PROJECT	Brickline Greenway North Connector – Phase 2	ADDENDUM NUMBER	01
PROJECT NO.	14654 (GRG 308s)	DATE	9/1/2026
PROJECT LOCATION	St Louis, Missouri		
CLIENT	Great Rivers Greenway		
PREPARED BY	Hannah Higgins, SmithGroup

ADDENDUM #01

Proposed changes include the following updates and the related pay item, bid tab, and JSP adjustments required:

CS5-407

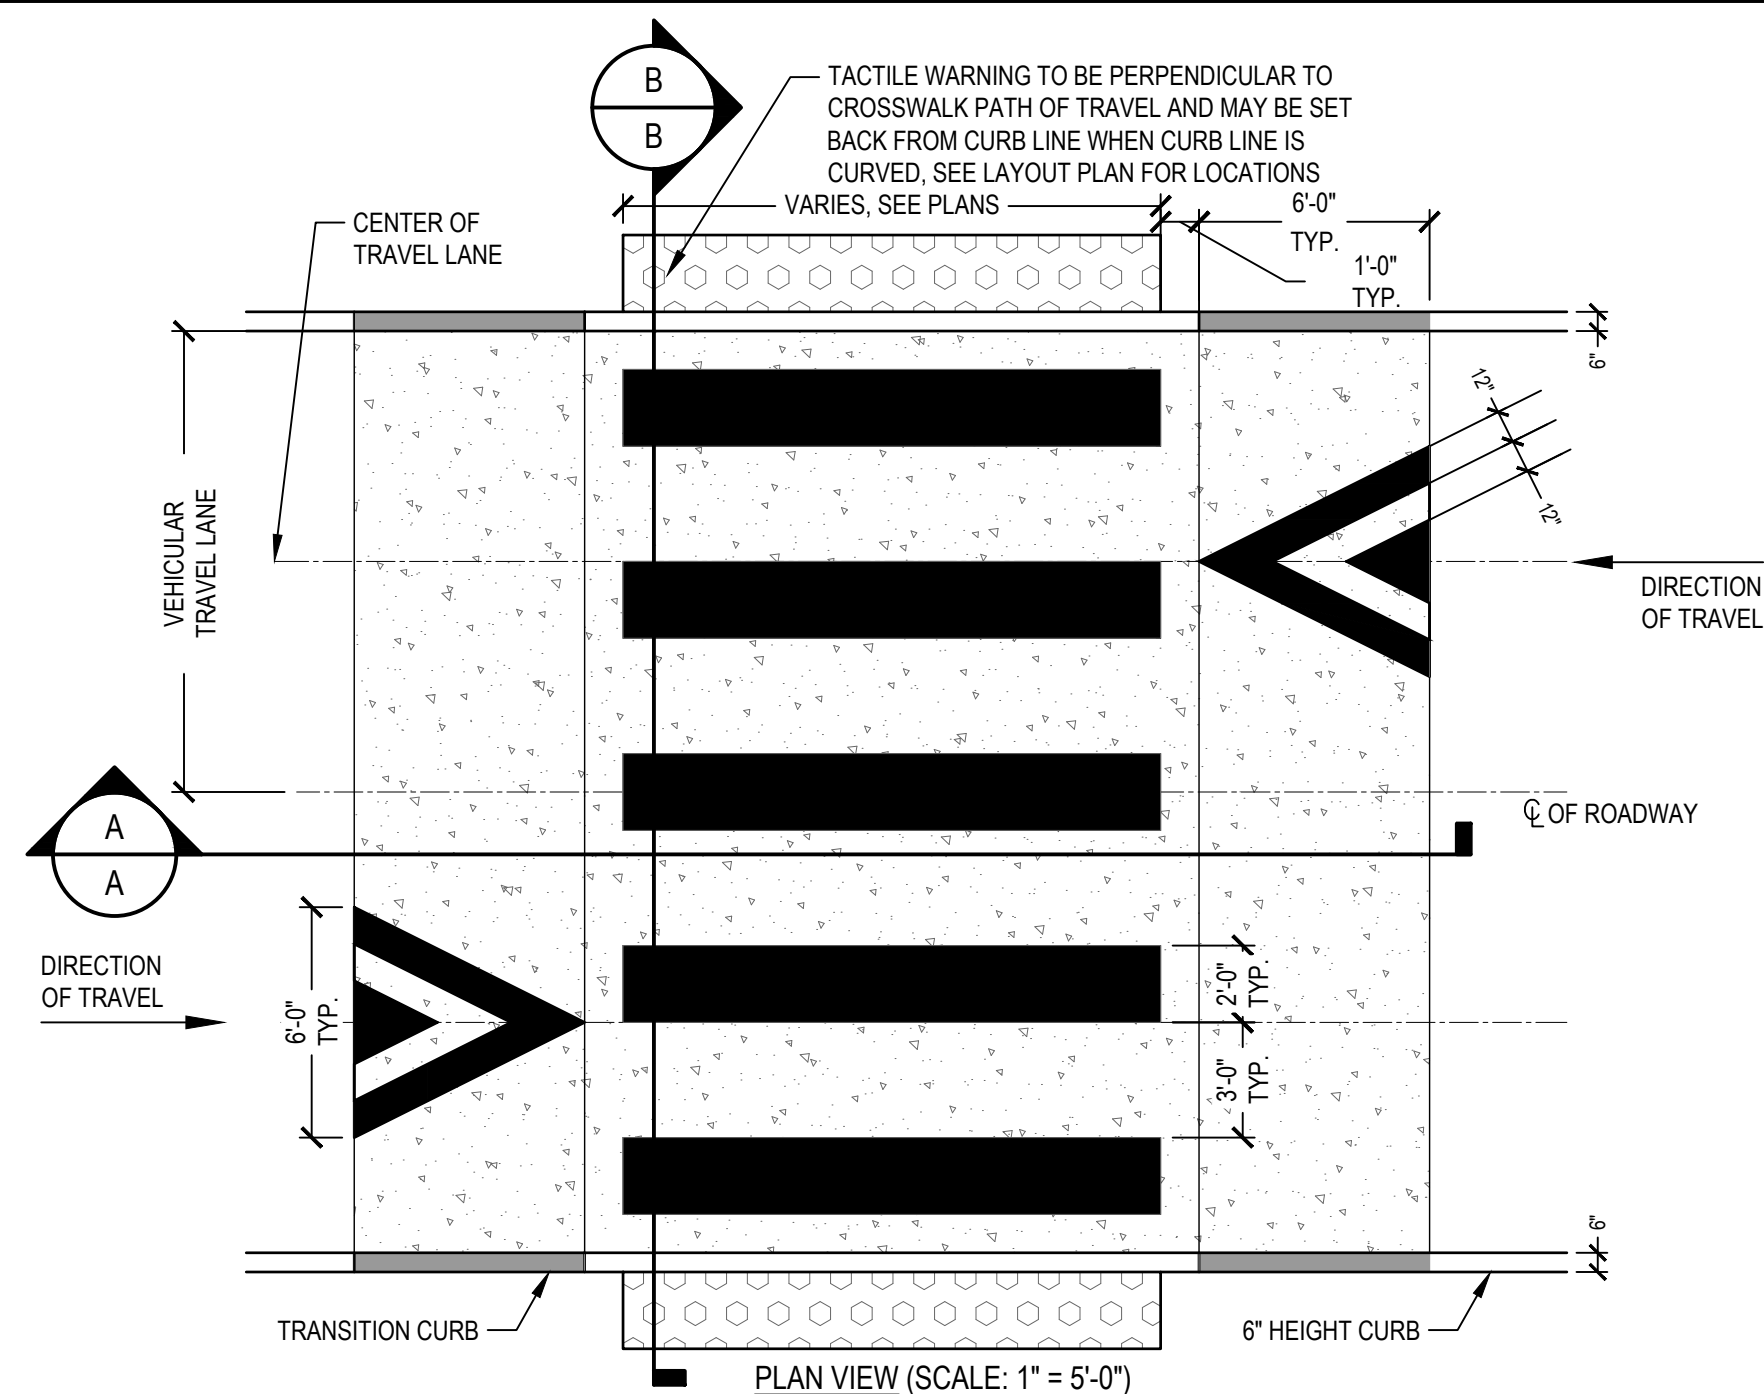
- E. CS5-402 LAYOUT AND MATERIALS PLAN ENLARGEMENTS: Alternate #2 added.
- F. CS5-407 LAYOUT AND MATERIALS PLAN ENLARGEMENTS: Plaza areas at Spring/Finney intersection updated.

CS5-503

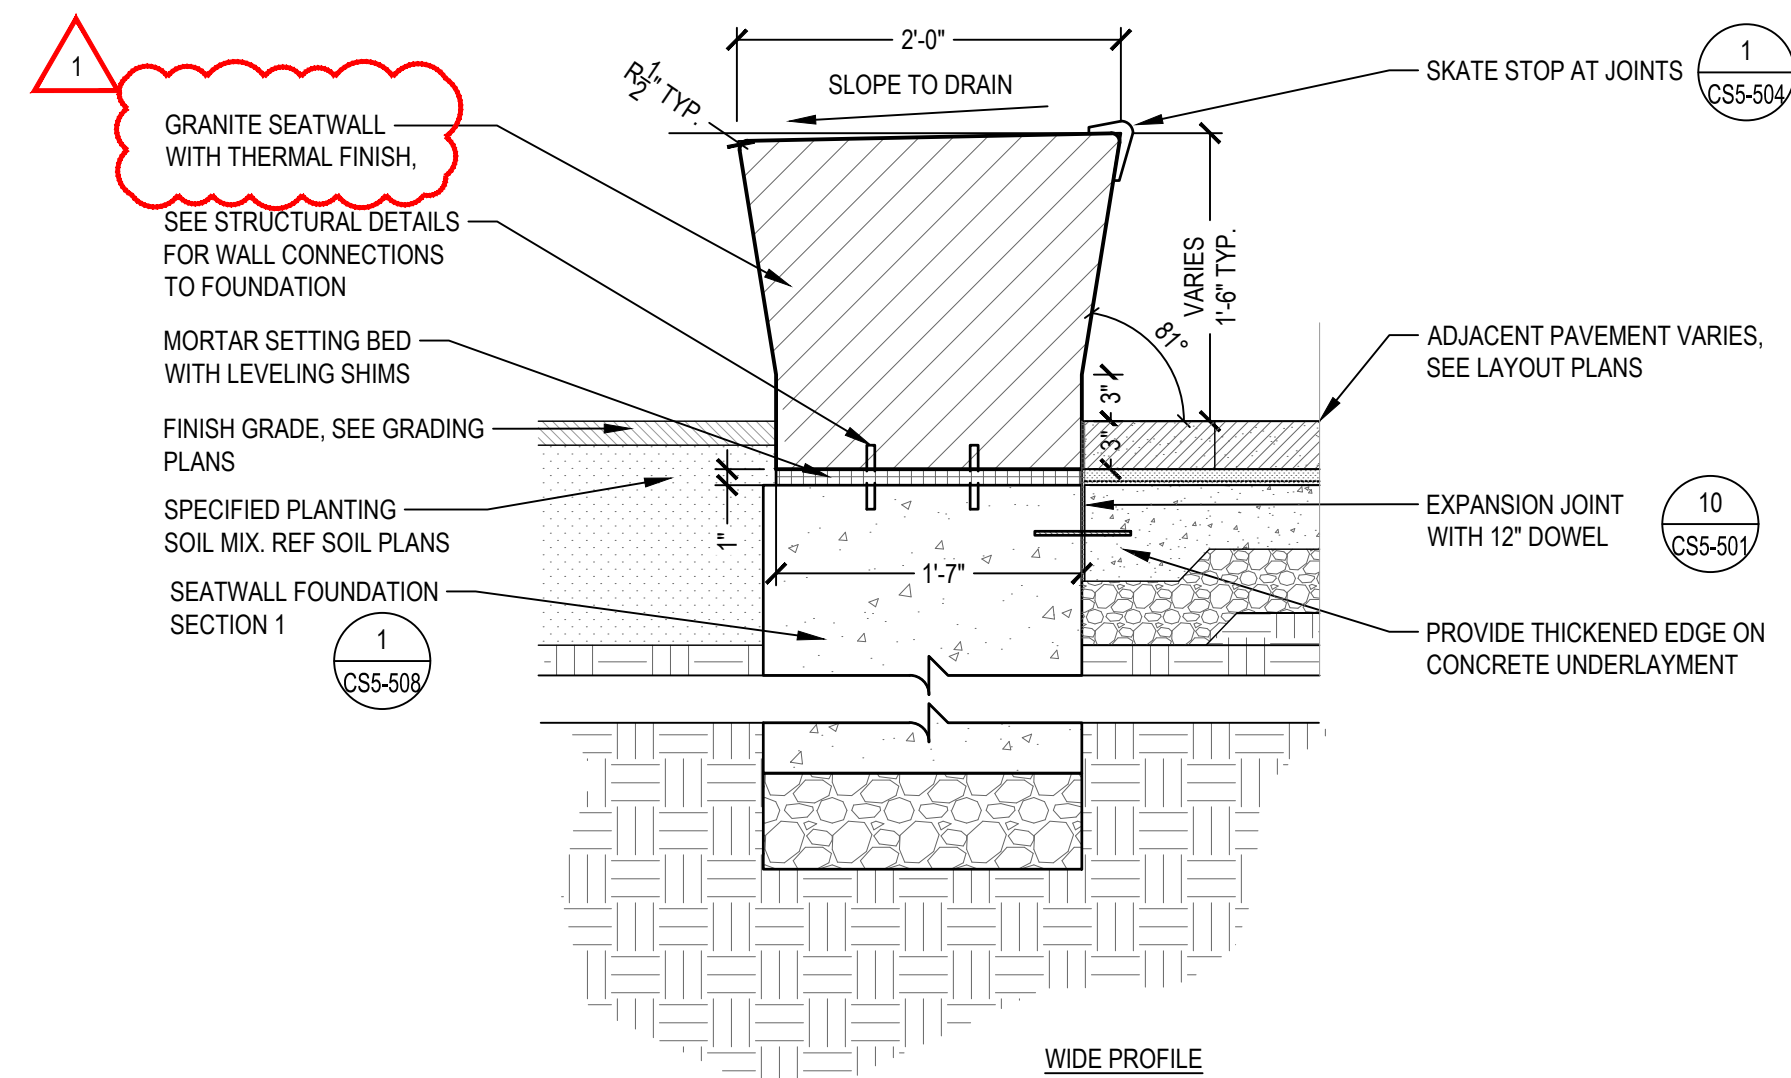
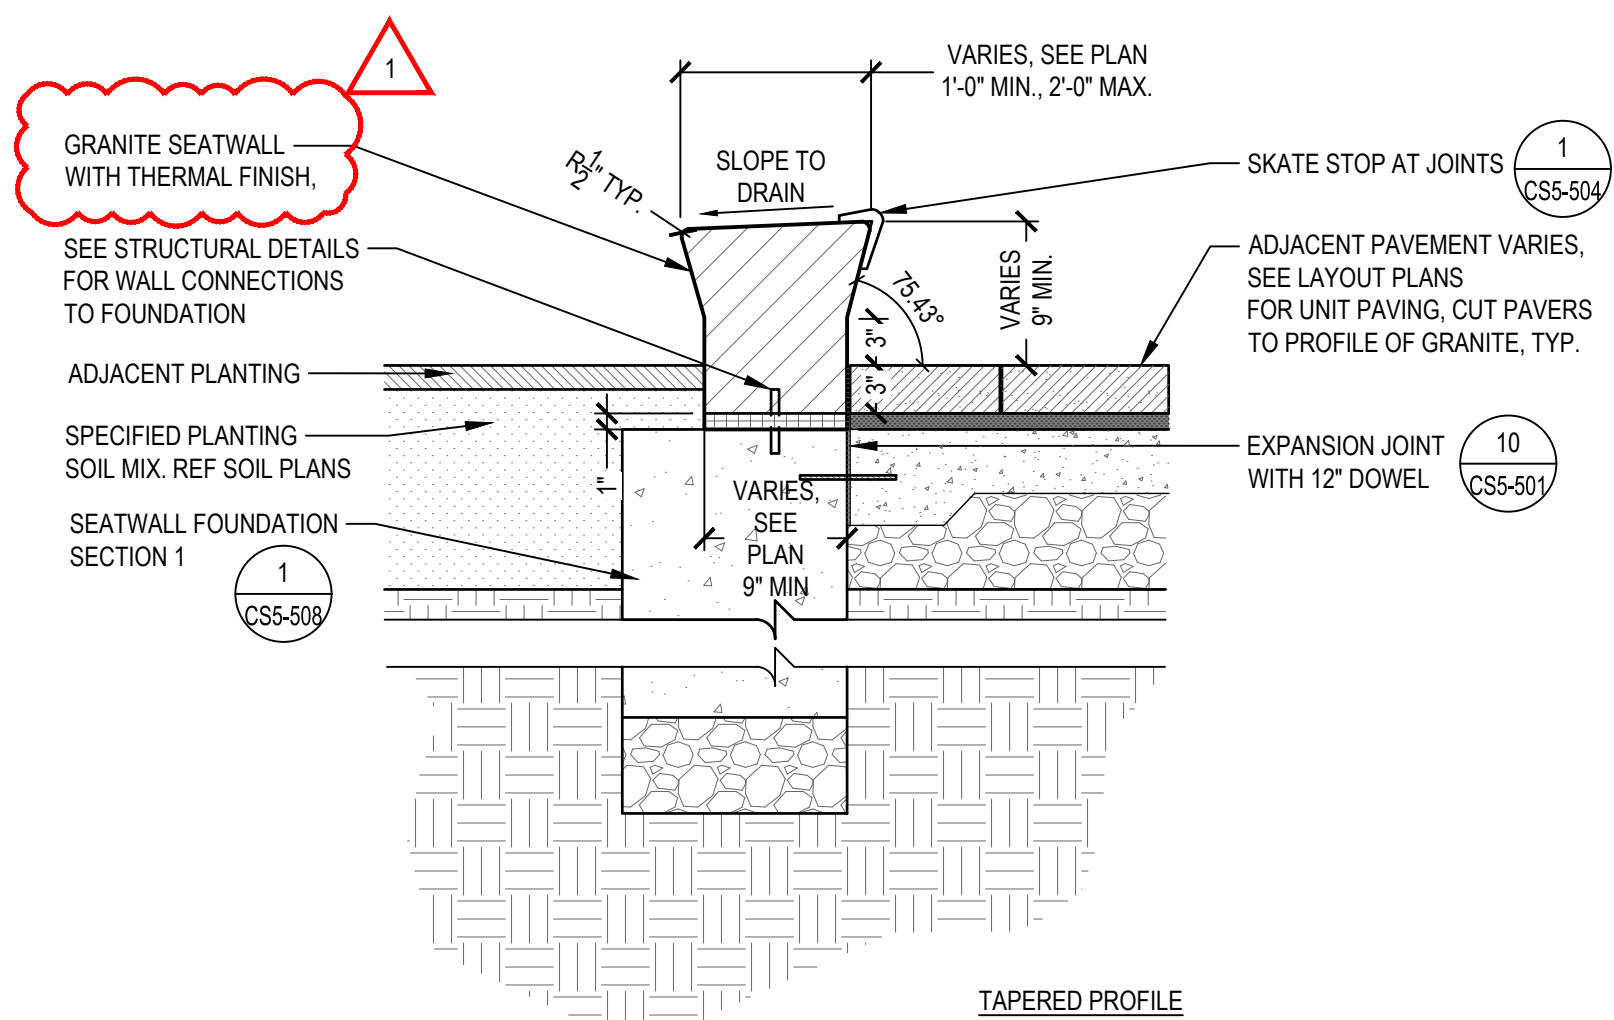
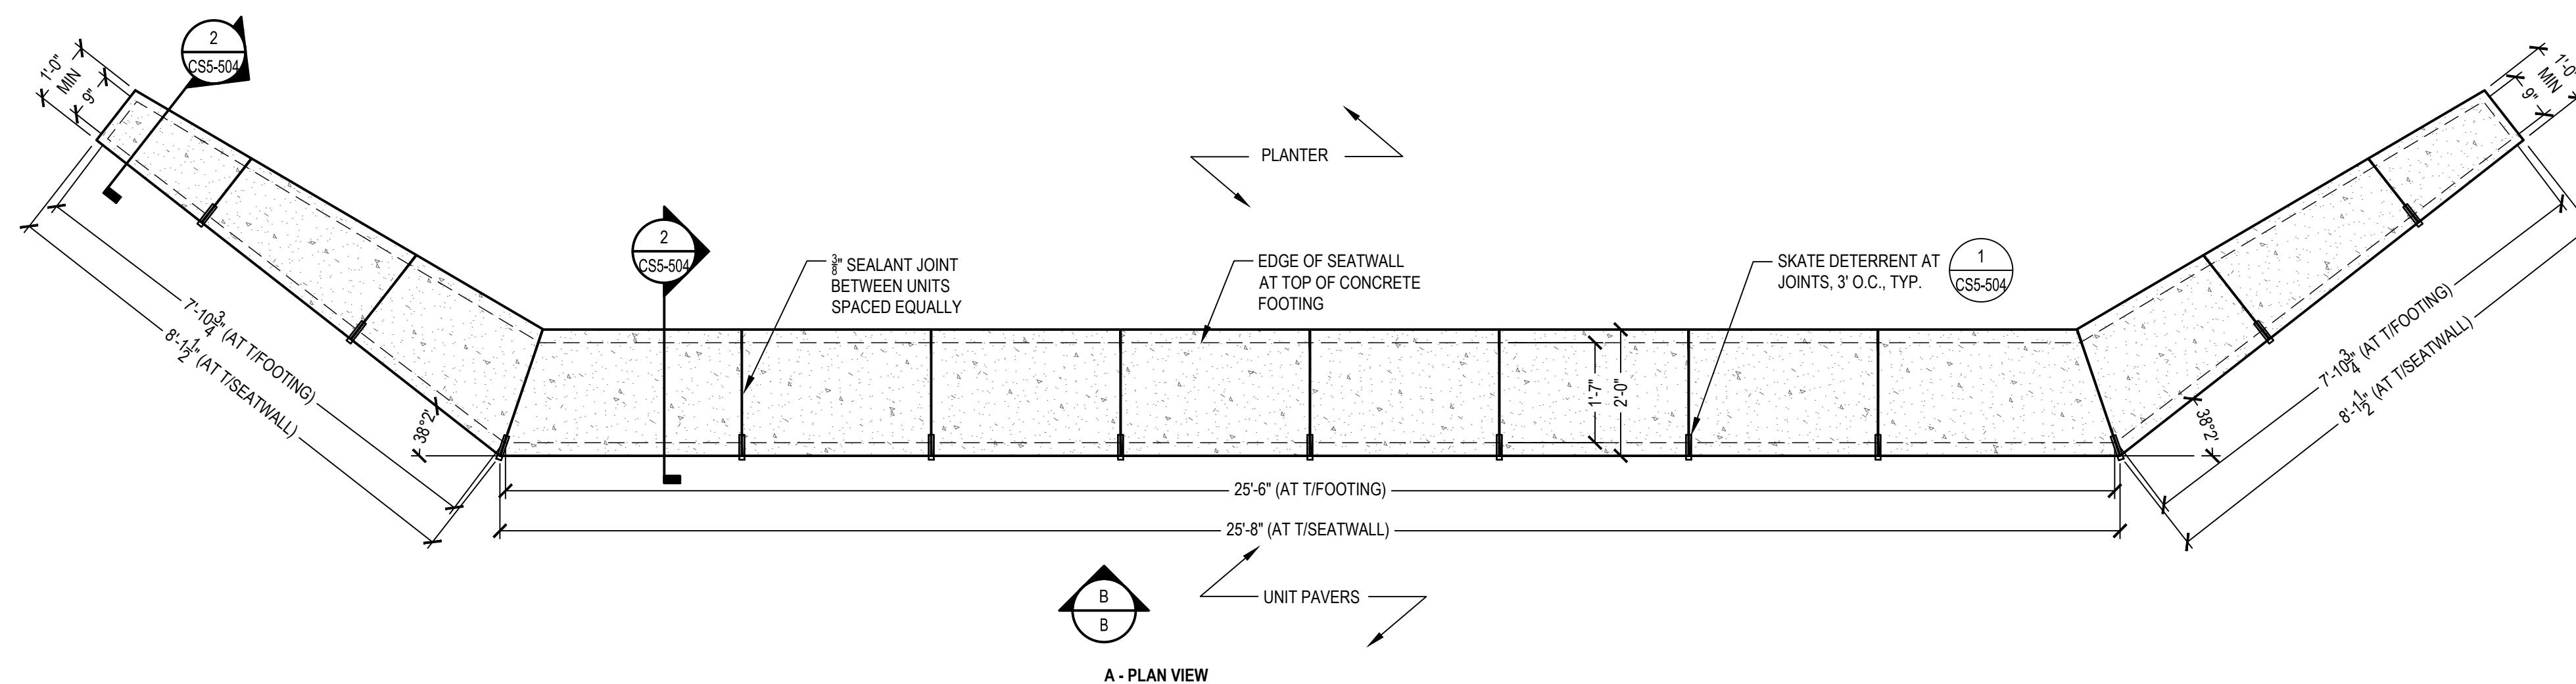
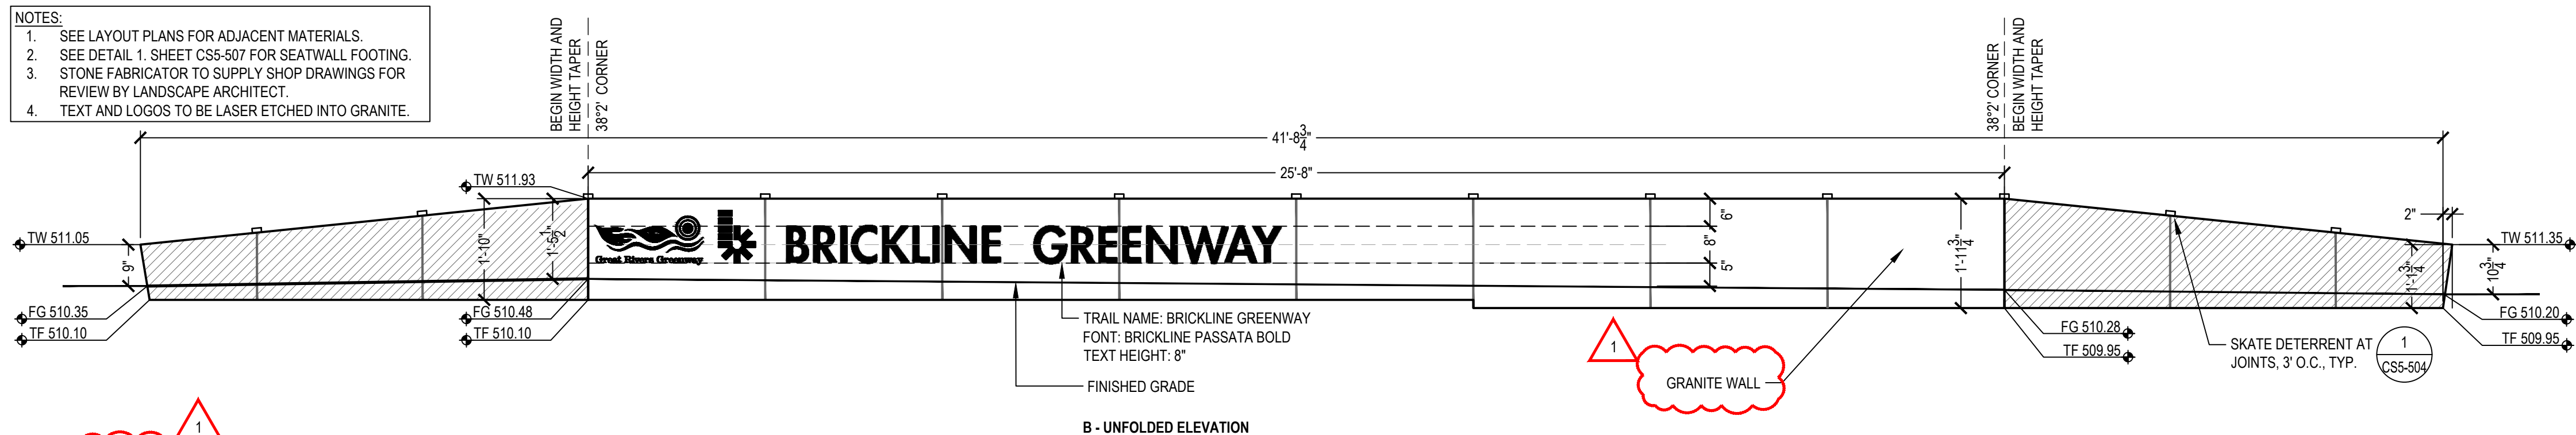
- G. CS5-503 SITE DETAILS: Detail 5 Cut Stone Steppers has been added.
- H. CS5-504 SITE DETAILS: Details 2 and 3 updated to reflect that all seatwalls are Granite.
